Re: Unlicensed Use of the 6 GHz Band, ET Docket No. 18-295; Expanding Flexible Use in Mid-Band Spectrum Between 3.7 and 24 GHz, GN Docket No. 17-183

AT&T Services, Inc., on behalf of itself and affiliates and subsidiaries of AT&T Inc. (collectively, “AT&T”), files this *ex parte* letter to discuss certain errors in the draft order circulated by Commission in the 6 GHz proceeding.¹ In particular, this letter addresses the flawed technical determinations made in the *Draft Order* in permitting the deployment of unlicensed “low-power indoor” (“LPI”) radio local area network (“RLAN”) devices at a power spectral density (“PSD”) limit of 5 dBm/MHz throughout the 6 GHz fixed microwave service (“FS”) band.

**ATTACHMENT 1
AT&T STATIC CASE TECHNICAL PARAMETERS**

Figure 2: Terrain Considerations for Example 2

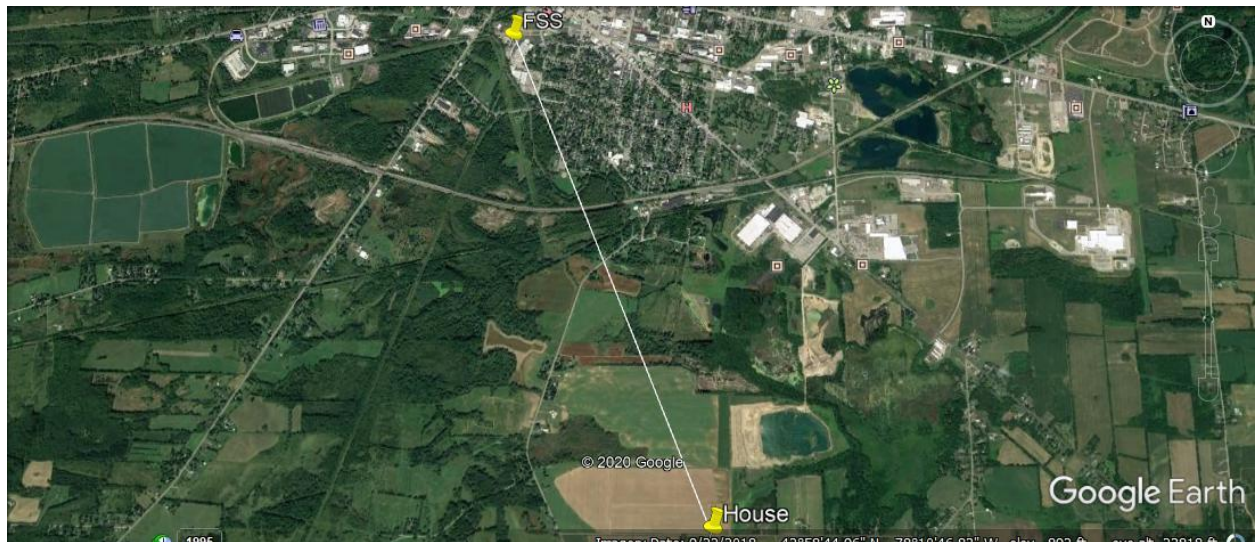
However, the table in the *Draft Order* contains other serious errors as well. In both Example 2 and Example 3, the *Draft Order* applies a -18.4 dB clutter loss factor. Looking at the terrain profiles and land area for both examples, however, shows that in both cases the value applied is radically overstated. In Example 2, a Google Earth terrain profile shows no terrain obstructions remembering that the microwave receiver is located 27.4 m above ground level and, that while the terrain profile exaggerates height differences, the total height variation in the profile is only 24 feet:

With elementary geometry, even if a tree was located at the worst point in the terrain profile, it would have to be in excess of 12 m tall to affect the microwave signal. And even if a few trees did reach that height, 18.4 dB of attenuation is vastly overstated. At most, even in the worst case, 10 dB of attenuation would be conservative.
